Memo

To:	Paul Ryan – Hamilton City Council		
From:	Alan Gregory – Principal Transport Planner, Tonkin + Taylor	Date:	20 May 2025
Subject:	Rotokauri Strategic Infrastructure Requirement – Technical Specialist Report for Section 42A Reporting		
Technical Area:	Transportation		
Version:	Final

Figure 2: Composite sketch drawing¹⁹ showing key transport elements

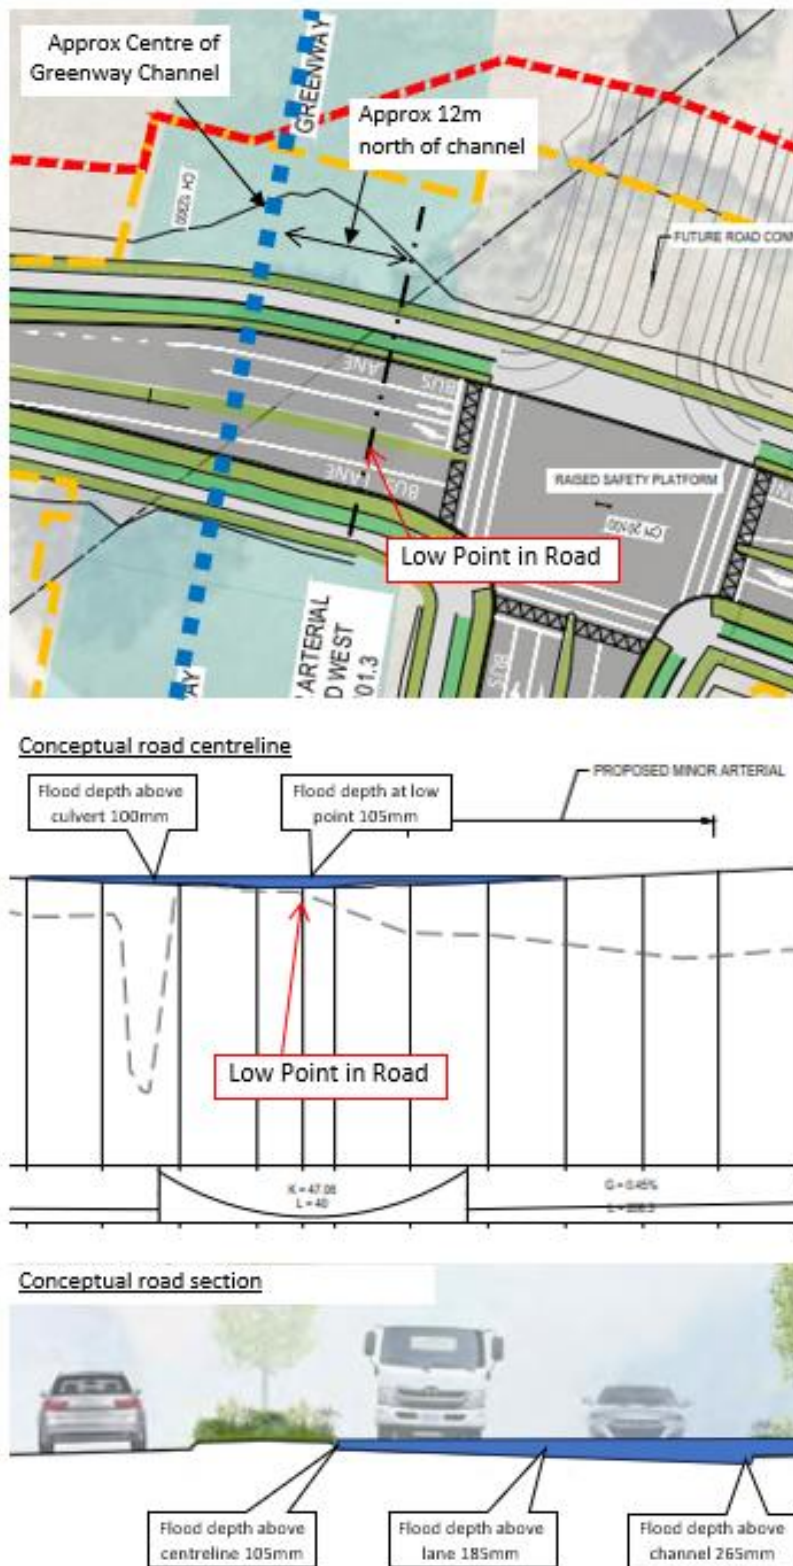
28. During an extreme storm event, the NOR design provides for overland flow across the north-south minor arterial where it crosses the Rotokauri Greenway.¹⁵ This has been highlighted as a risk within section 3.1 of the Road Safety Audit. I note that the Requiring Authority has highlighted that this is only likely with a 1 in 100-year storm event and that the maximum flood depth would be 100mm at the road centre line. Whilst I recognise this is a rare occurrence, the water depth in the traffic lane immediately adjacent to the proposed Te Kowhai Road West Extension intersection with the minor arterial would likely exceed the ability for normal road vehicles to safely pass the flooded area (i.e. exceeding 150mm adjacent to the kerb)¹⁶ because of the combination of the concept design alignment low point¹⁷ and road camber. RITS states¹⁸ 150mm is the flood depth at which vehicles will float. To illustrate this is shown in **Figure 2** below.

29. I note that in its response to the road safety audit, the Requiring Authority has stated that the SH1C underpasses will also become blocked during this intensity of storm, meaning that the north-south minor arterial will be the only link to the wider transport network as an escape route for residents or for access by emergency vehicles.
30. Whilst the storm event is described as a 1 in 100-year occurrence, I consider that the likelihood of this type of storm event could be more frequent in the future, which is discussed in Robert Kelly's memorandum (see his paragraphs 17 and 86 b i) and could result in more frequent road blockages.
31. I suggest that, during Detailed Design, the Requiring Authority assesses an alternative to an overland flow at this location.

Figure 3: Extent of the Requirement covered by Hounsell Holdings Ltd's Fast-Track concept design²⁵

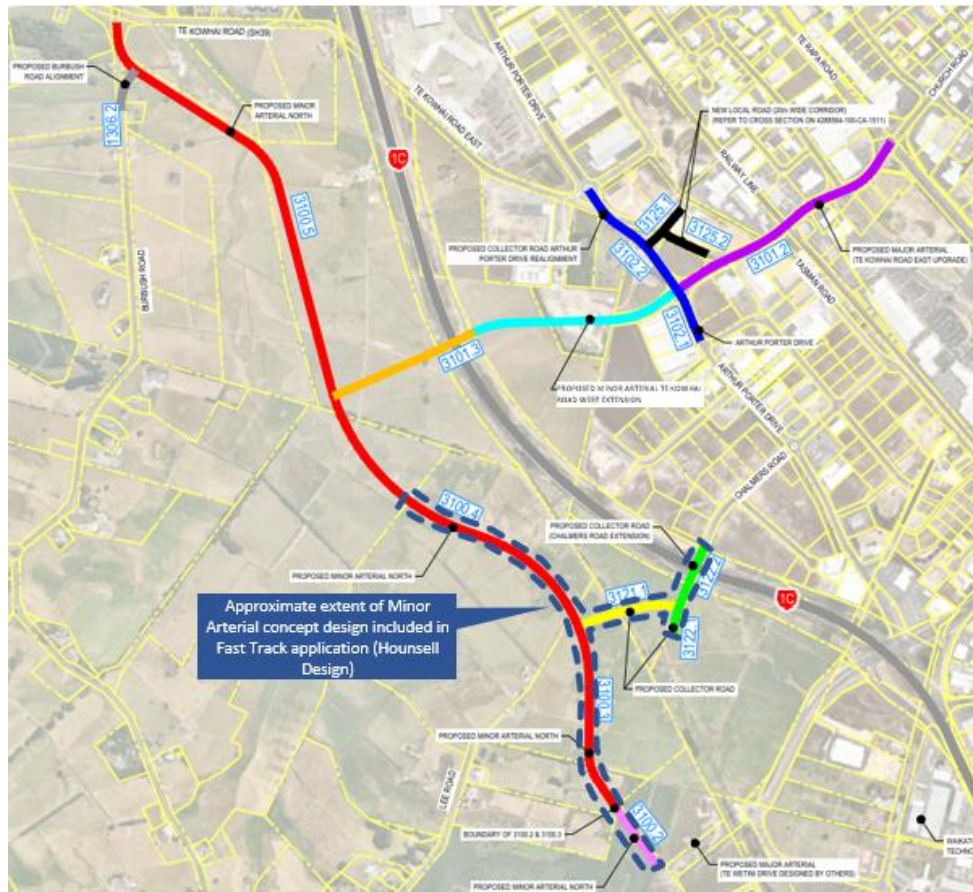
44. No evaluation has been provided for the following key intersections to which the proposed arterial roads will connect: Te Rapa Road, Te Wetini Drive, Arthur Porter Drive (at Chalmers Road), and Te Kowhai Road (SH39).

- 98. The submitter is seeking for the proposed transport corridor cross sections shown in the NOR to be updated to reflect the cross-sections in the proposed detailed design that the submitter is developing, on behalf of the Requiring Authority, for the southern section of the Requirement, the extent of which is shown in **Figure 3** below.²⁴

99. The cross sections are compared in Table 3 below.
